LBC comment

Balustrade

Union Terrace Gardens

19	Section 15 Balustrade 6	Crack through bottom neck	
20	Section 16 Slab 5	Big chip on outer side

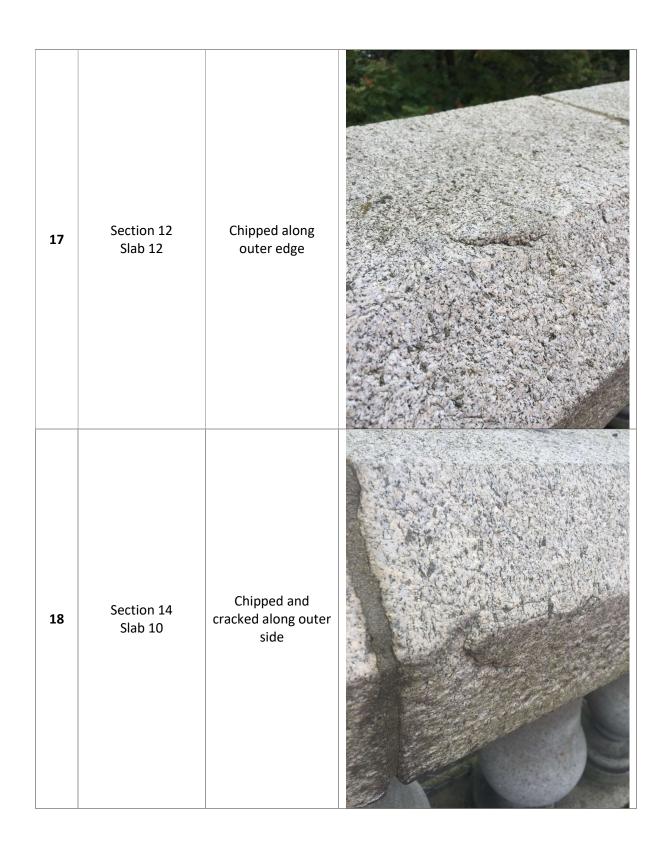
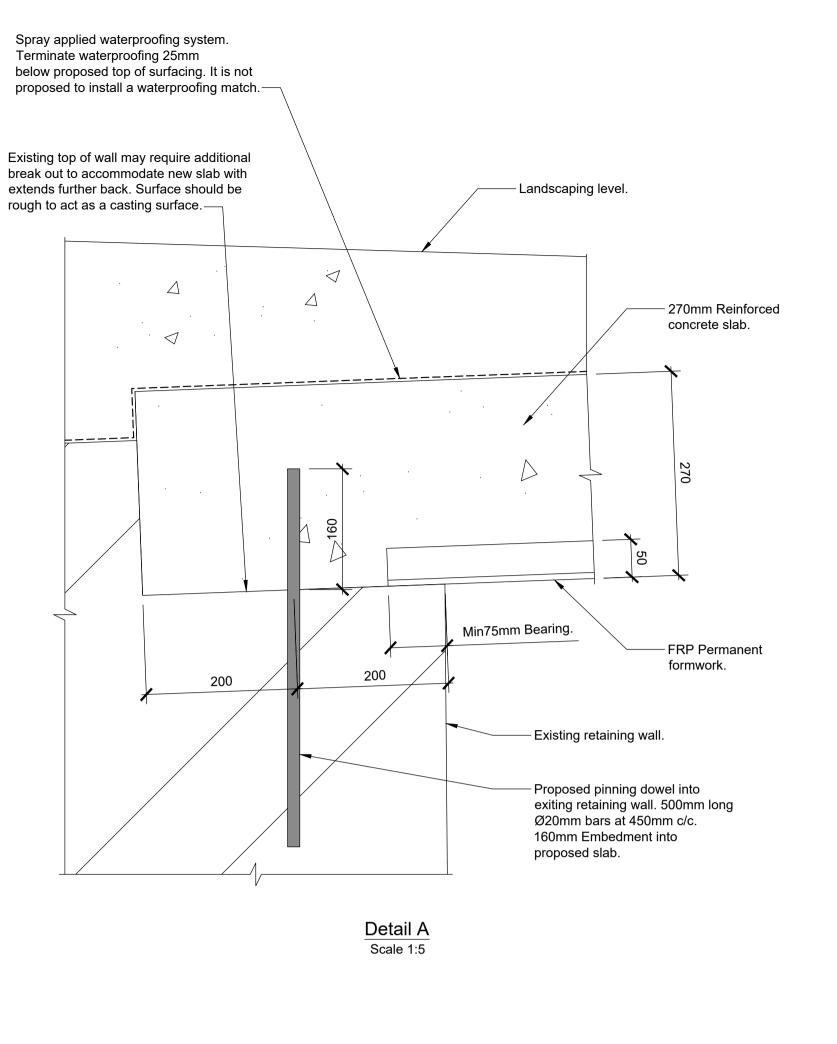
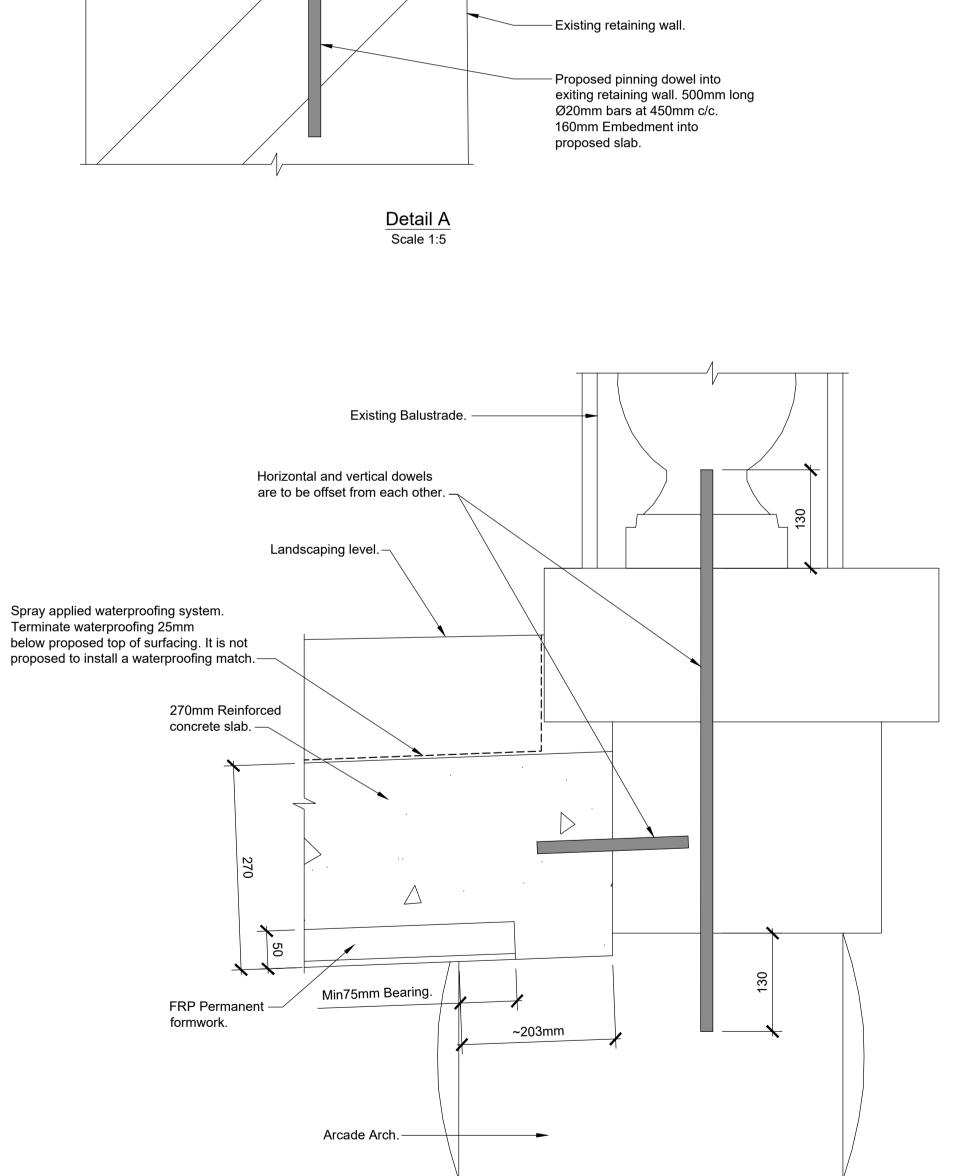
That no works to remove the balustrade around the Gardens at street level shall take place unless a detailed methodology carried out by a qualified specialist for its removal, repair, storage, strengthening and reinstatement have been submitted to and approved in writing by the planning authority. Thereafter no works shall be carried out unless in complete accordance with such details as so approved unless otherwise agreed in writing with the planning authority.

- Before works can start a detailed record of the existing balustrade will be done by BB to high light any existing damages and positions of individual items within the balustrade (see appendix 1).
